ALLAMAKEE CSD MIDDLE SCHOOL HVAC UPGRADE
WAUKON, IOWA

ADDENDUM 02
March 6, 2026

MECHANICAL PLAN - AREA A

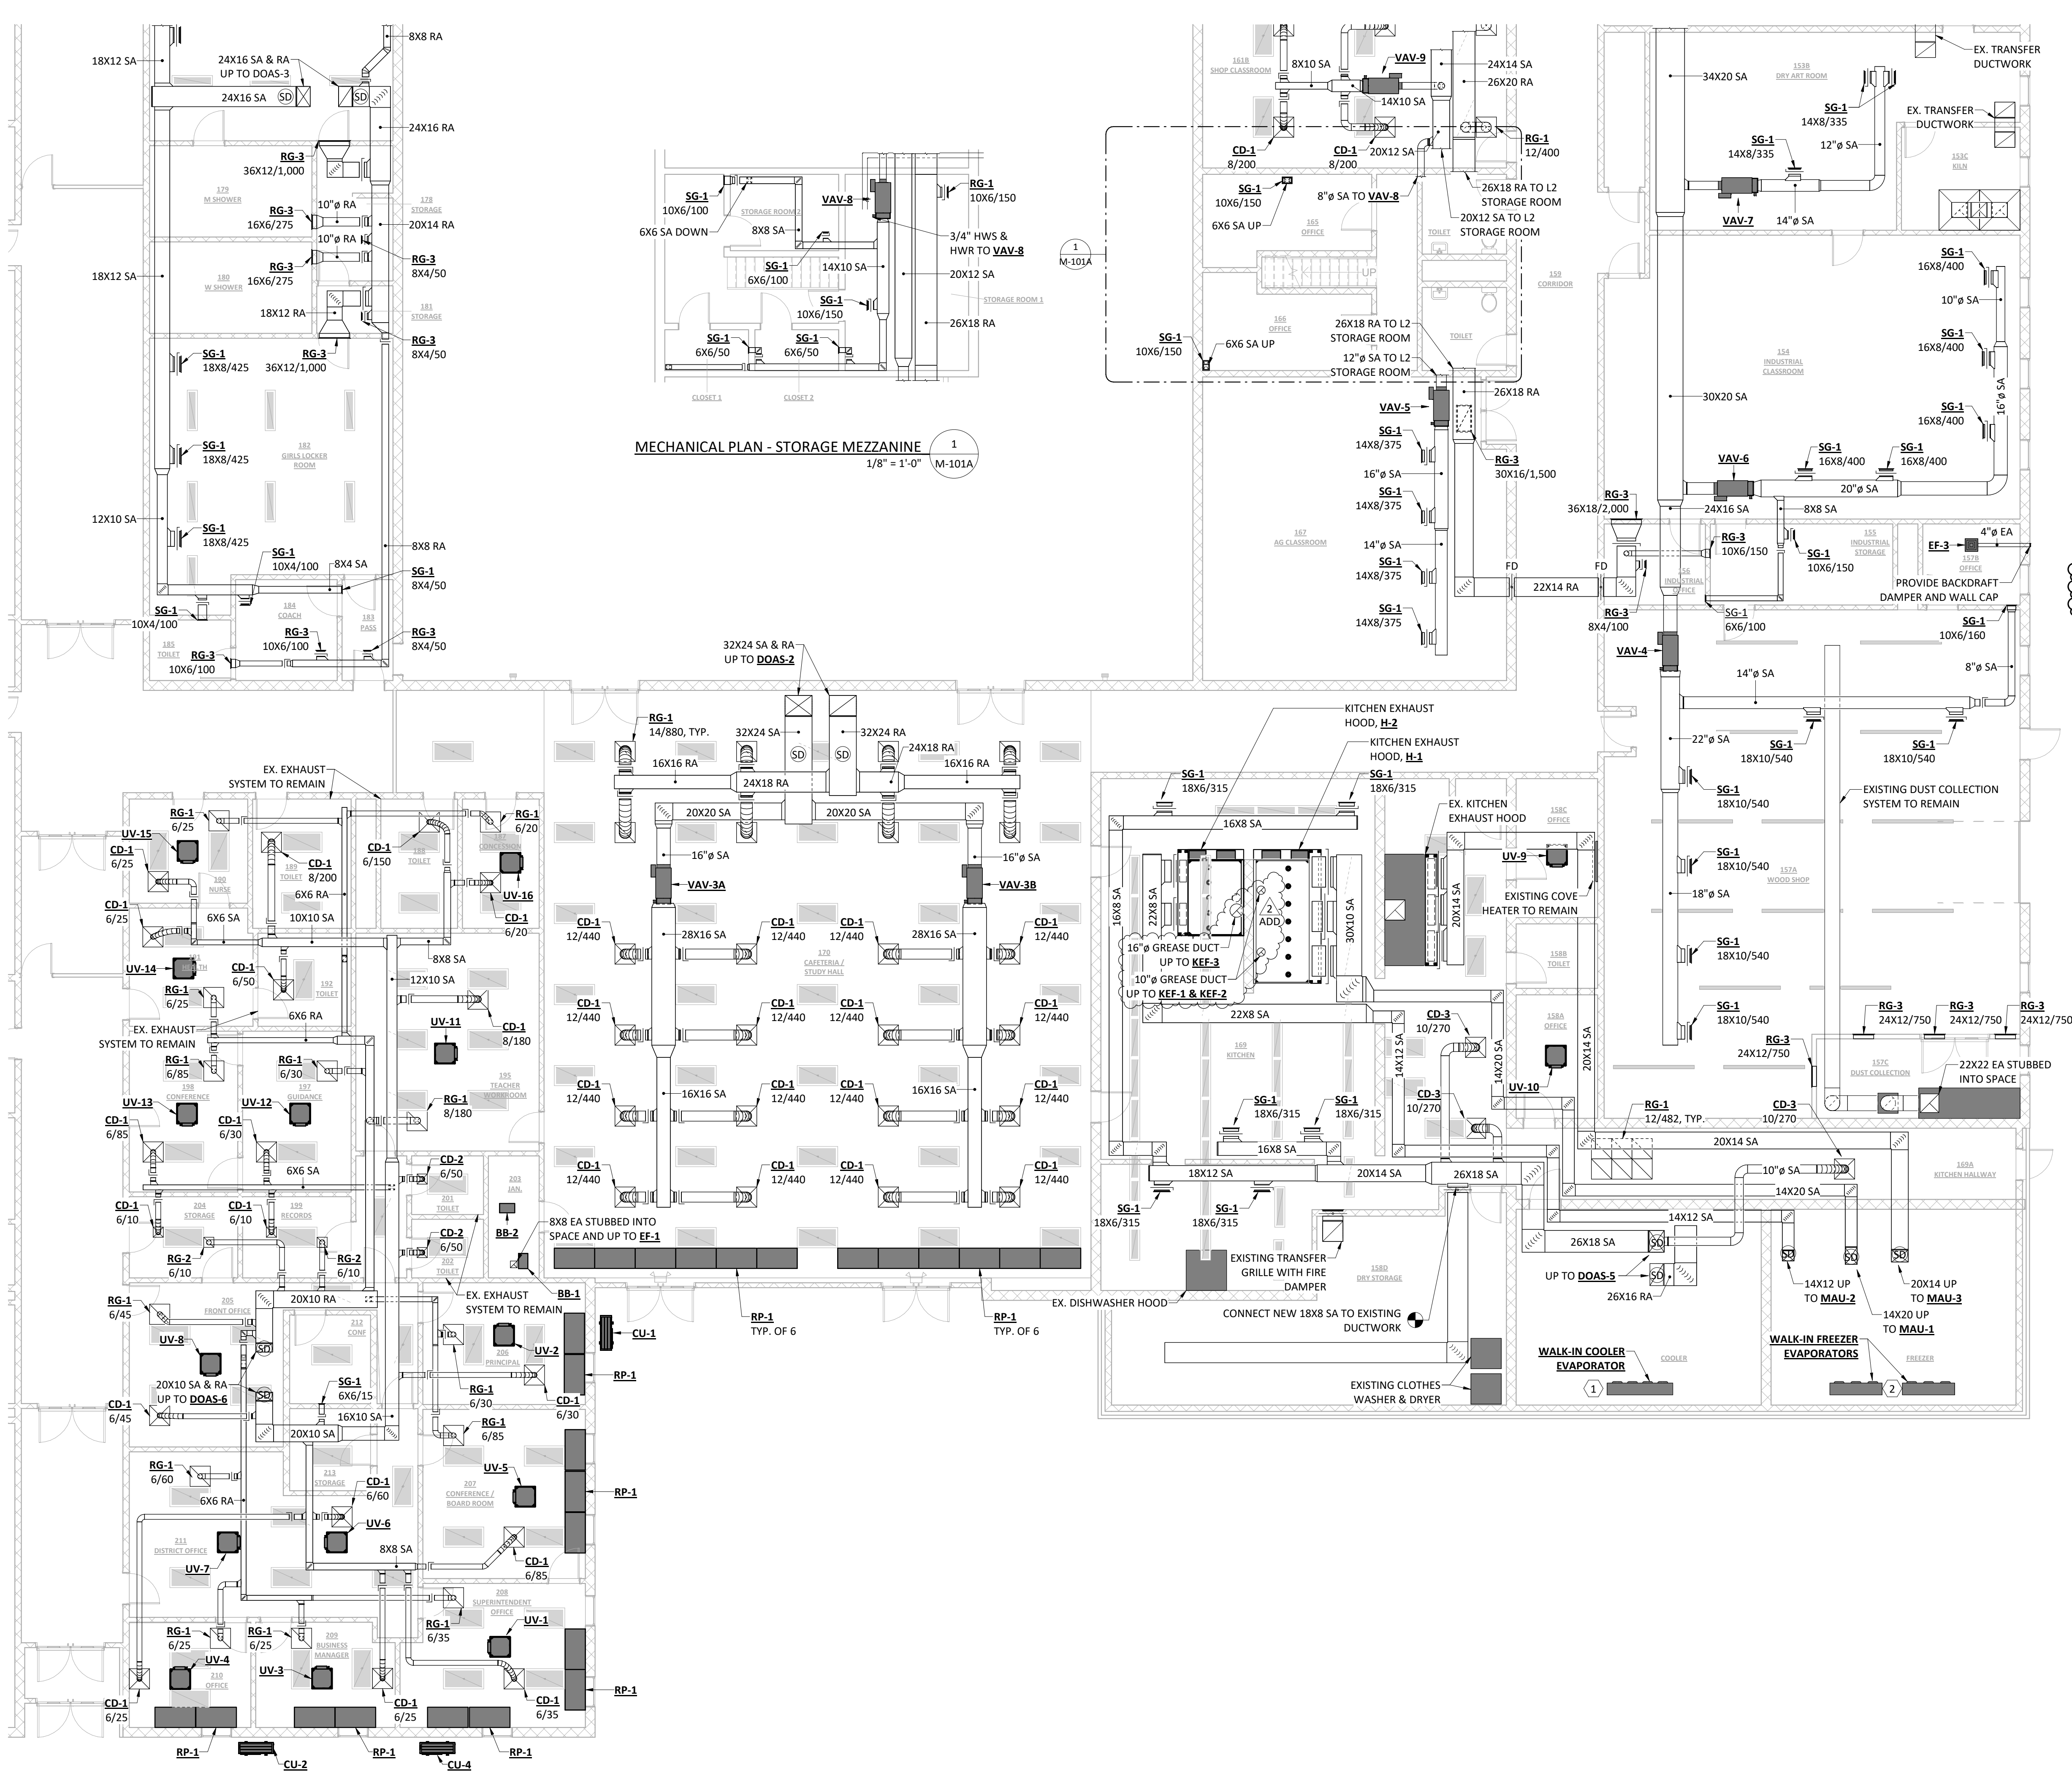
- M2-1 Drawing **M-101A – MECHANICAL PLAN – AREA A**
2. Added notes for grease ductwork sizes up to associated fans.
 3. Added note to provide ‘paint grip’ finish for all exposed round ductwork except within room WOOD SHOP | 157A.

MECHANICAL PLAN - AREA B

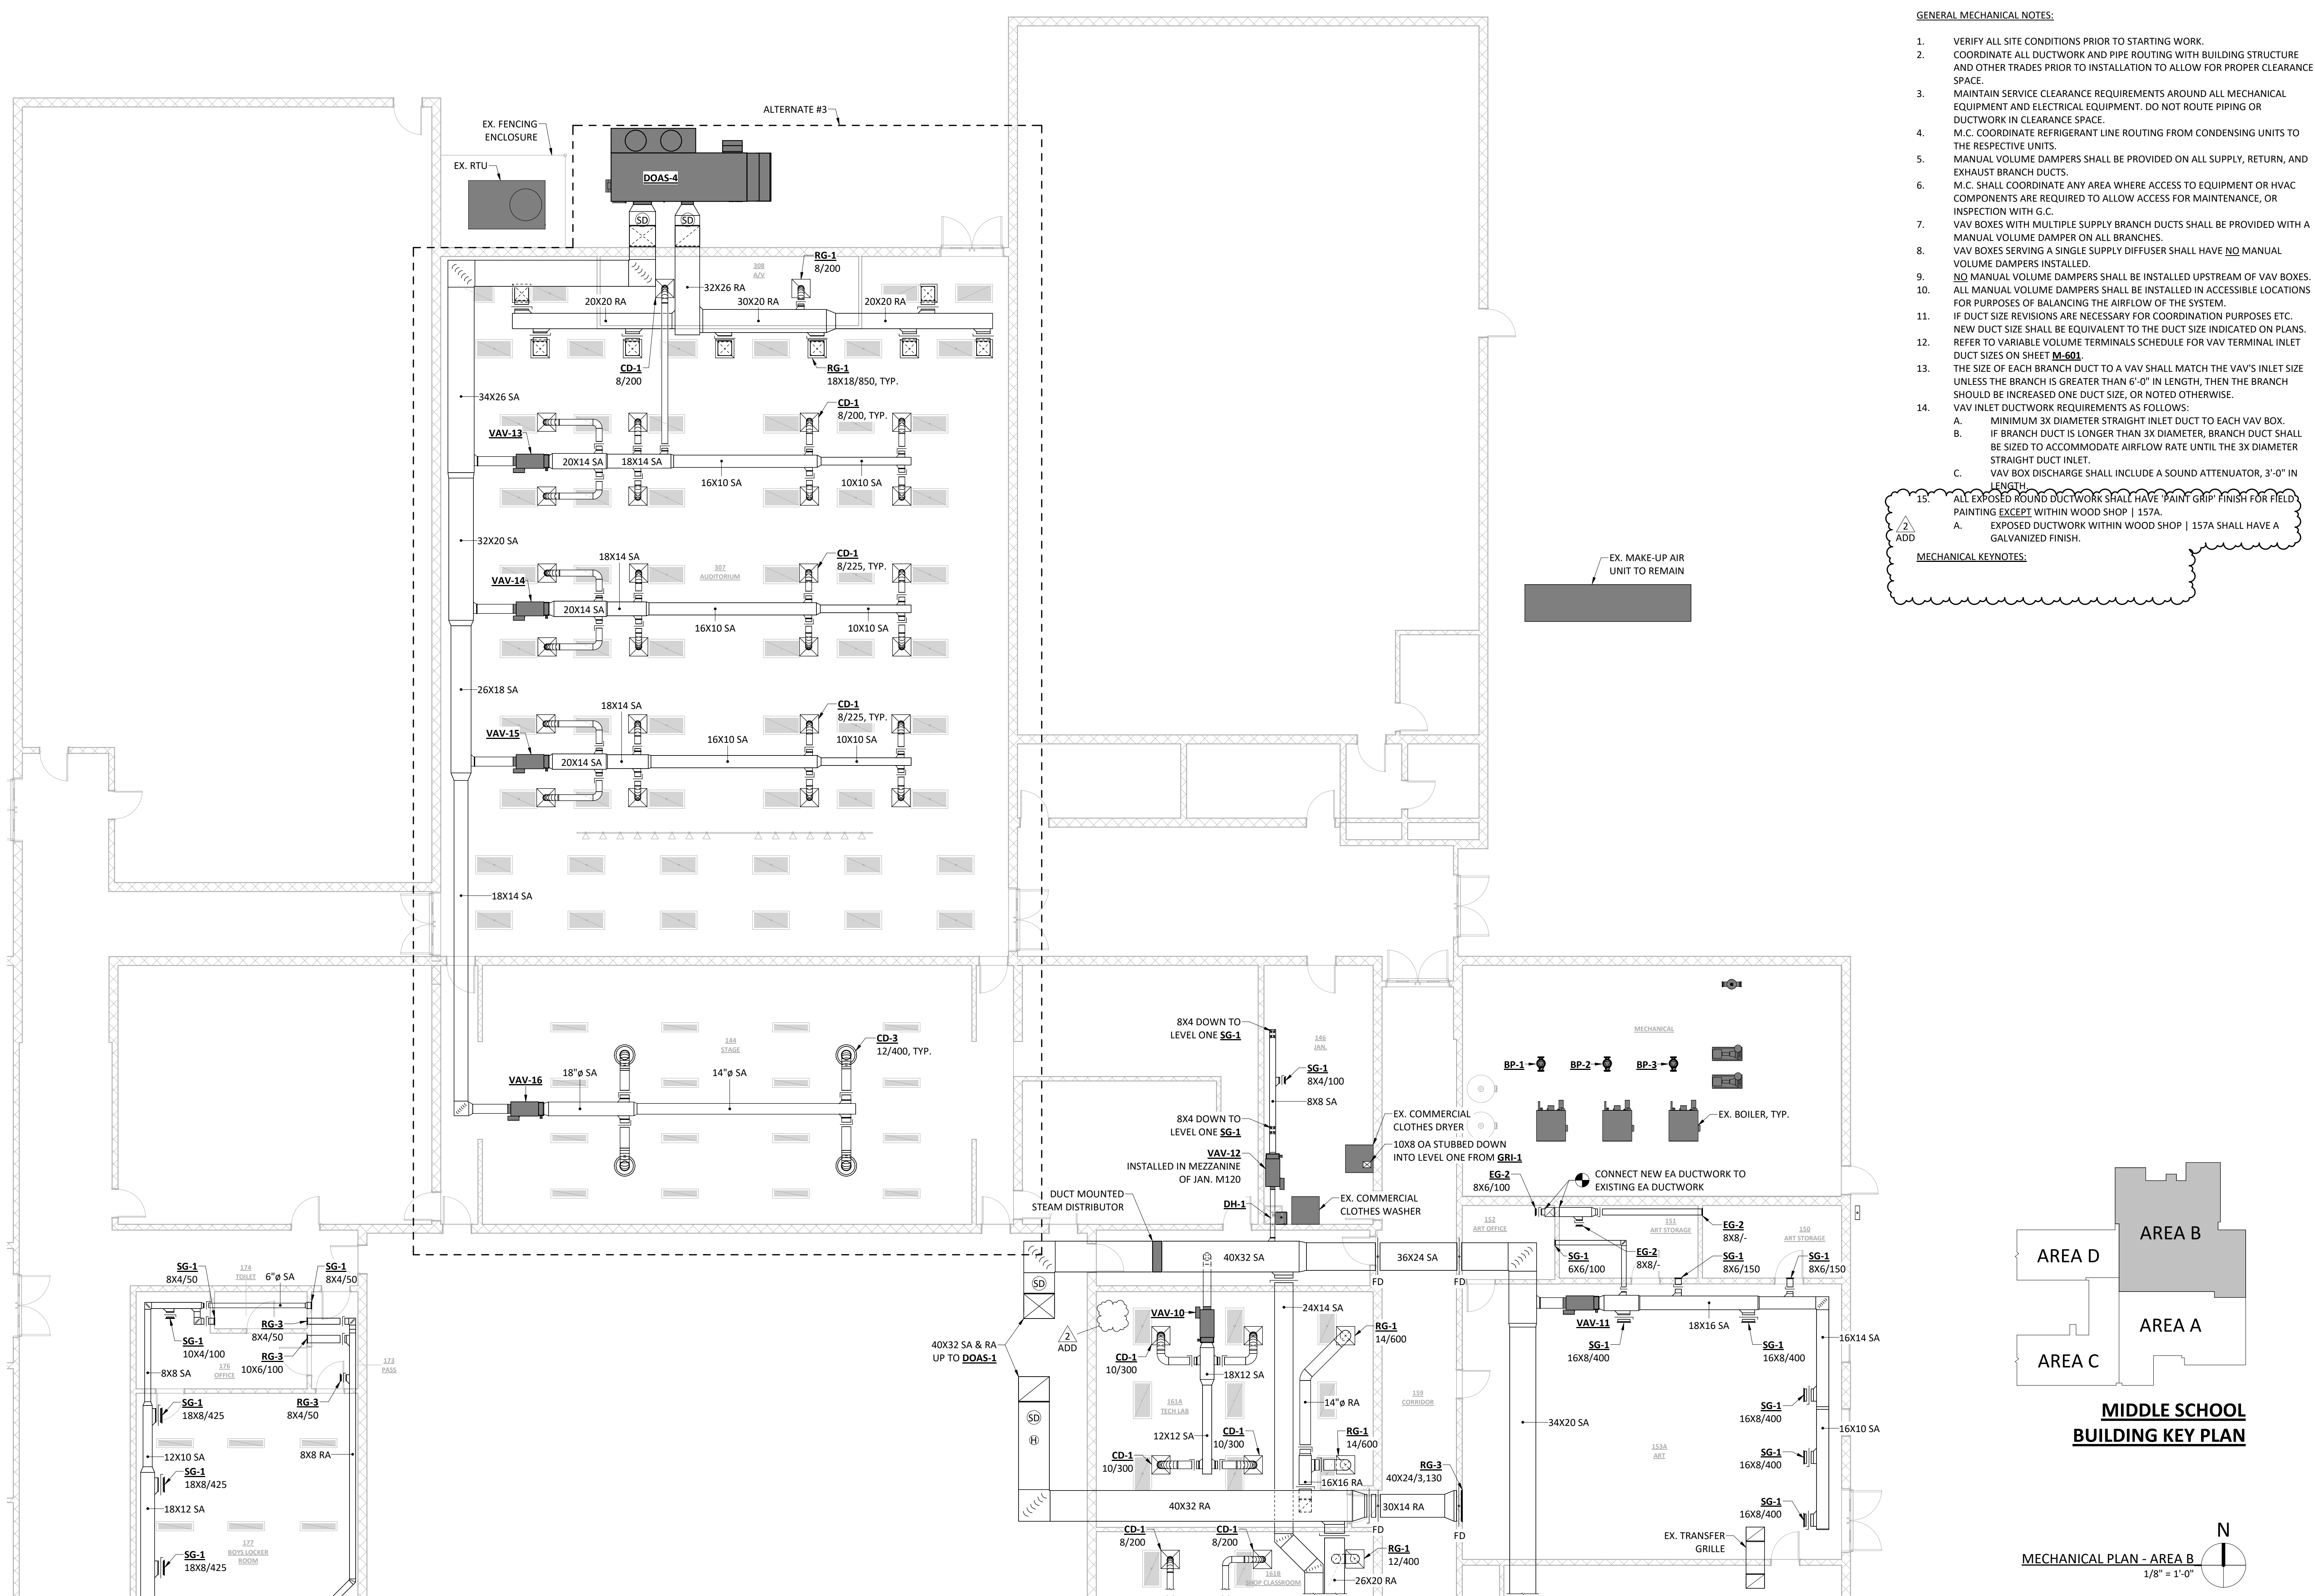
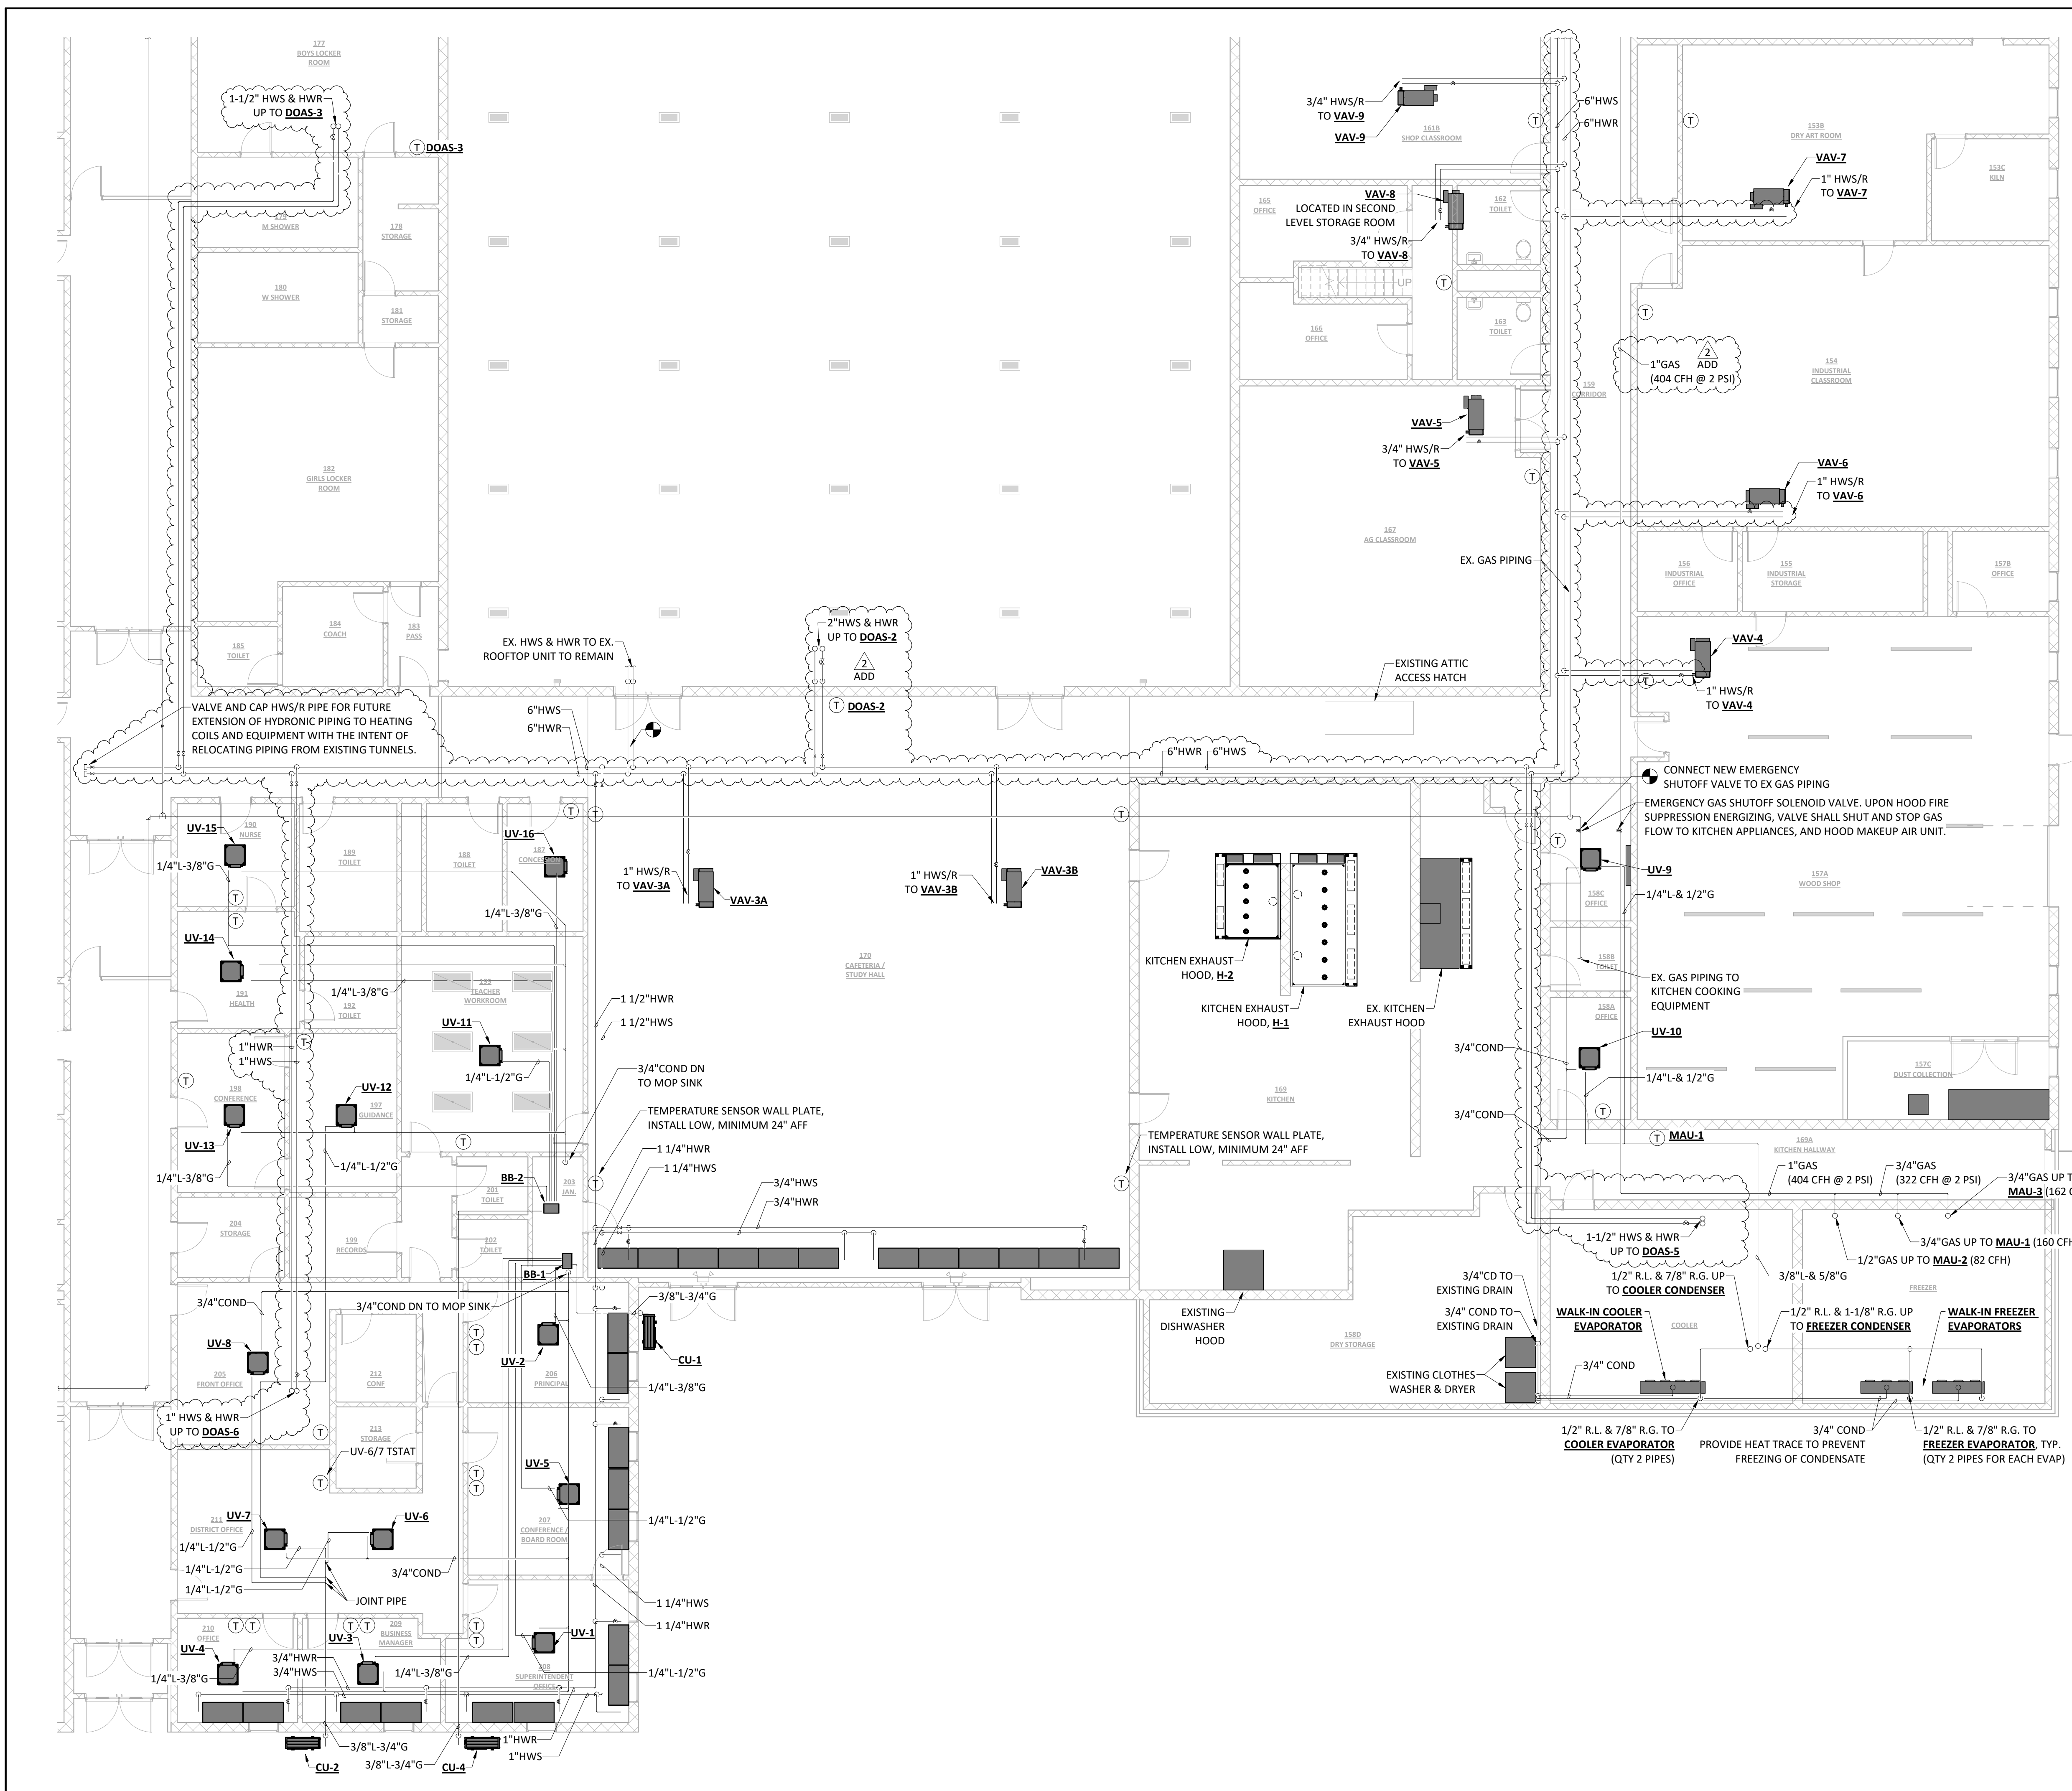
- M2-2 Drawing **M-101B – MECHANICAL PLAN – AREA B**
1. Added note to provide ‘paint grip’ finish for all exposed round ductwork except within room WOOD SHOP | 157A.

2. Removed Mechanical Keynote 1.
- M2-3 Drawing **M-111A – MECHANICAL PIPING & CONTROLS PLAN – AREA A**
1. Removed gas piping to DOAS units DOAS-1, DOAS-2, DOAS-3, DOAS-5, & DOAS-6.
